PORTFOLIO HOLDER DECISION NOTICE

TOPIC – TRAFFIC REGULATION ORDER – ANDOVER ROAD, BRUNEL CLOSE, MILL PLACE, NEW ROAD AND OVERTON ROAD, MICHELDEVER STATION

PROPOSED WAITING RESTRICTIONS
 MICHELDEVER STATION

DRG. No. 810402/221/001 A

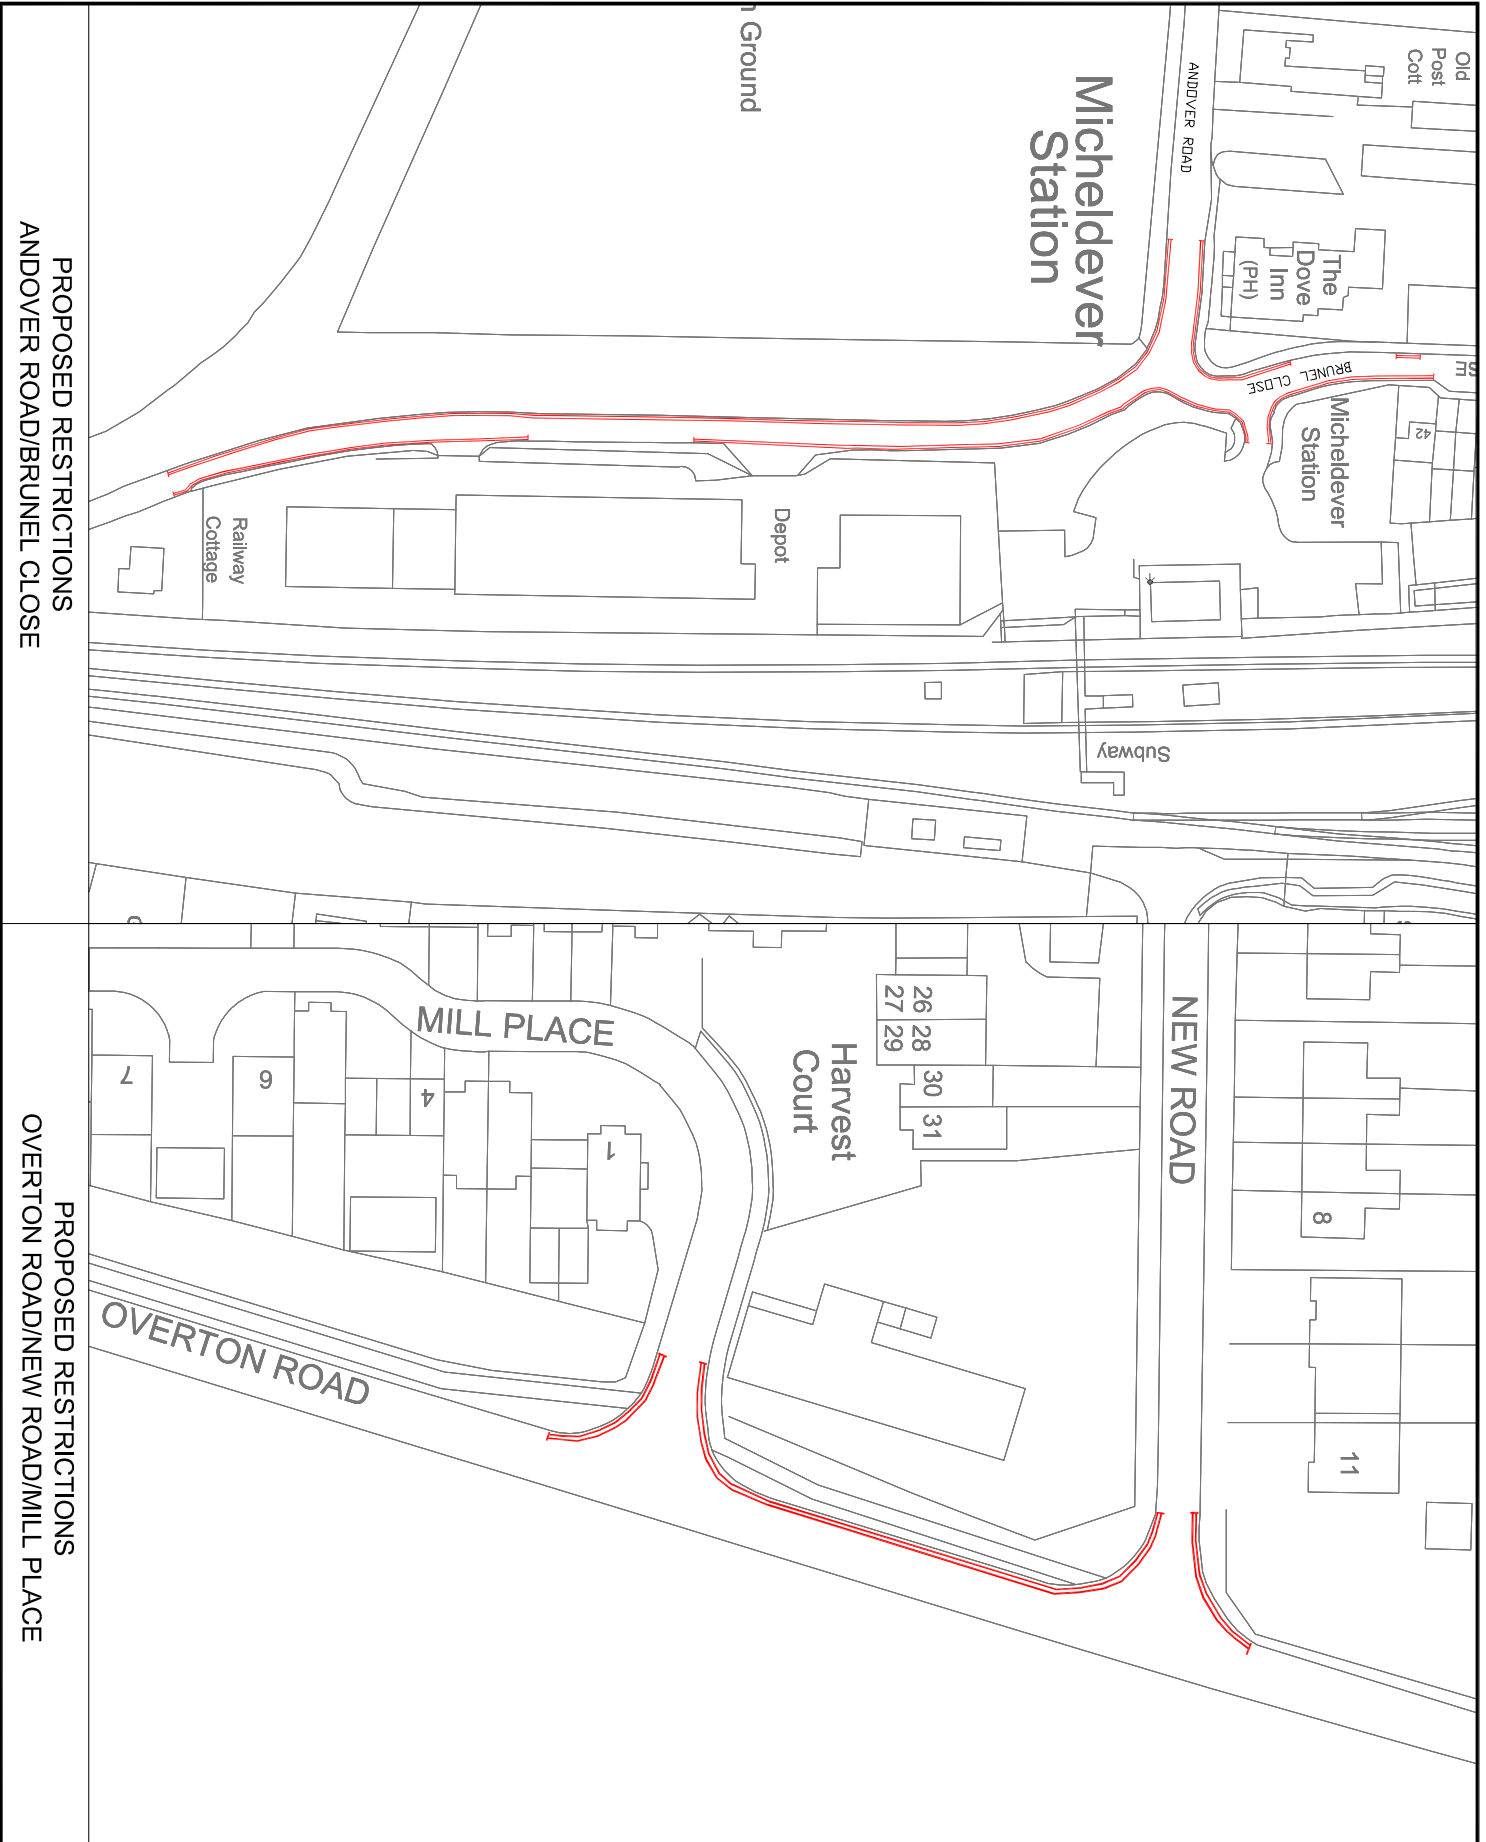
While it is appreciated that something is being done to prevent dangerous parking at this junction, I noted from the drawing that the restriction to the South of the Mill Place/Overton Road junction is only right on the corner. Would it be possible to extend the yellow lines further south of the junction to allow vehicles exiting Mill Place to have a clear view in both directions?

With the proposed restriction there will still be cars parked close to the junction making it extremely hazardous in trying to exit Mill Place

Our client is concerned to learn of the intended restrictions specifically those south of the junction of Micheldever Station with Brunel Close to the point just north of Railway Cottage, as set out on the plan enclosed with your letter.

As is evident from that plan, these particular restrictions about the "depot" from which our client carries on its business. Our client's concern is that the proposed restrictions along this part of the highway will have serious and considerable impact on its business. It is often the case that, at busy times, (such as weekends) the number of customers wishing to purchase fitted tyres leads to small queues of traffic which result in short delays in customers entering our client's premises. Such delays are usually no more than 5-10 minutes.

Having considered the relevant legislation, it is our view that static cars in queuing traffic do not come within the ambit of "waiting" for the purposes of the intended restrictions but if the Council has a different view we would welcome your comments and any relevant authorities upon which you rely.

Notwithstanding, our client believes the intended restrictions are unreasonable and unfair and is unable to understand why the same are required on that particular part of the highway. Despite the suggestion in your letter that the proposals are "minimal" there does not appear to be any justification for the extent of the restrictions suggested and we would be grateful if you can provide an explanation for the same.

| Rev. | Description | Date | Drawn |
|------|--|----------|-------|
| A | Restrictions extended in Overton Road. | 22/11/01 | NVC |
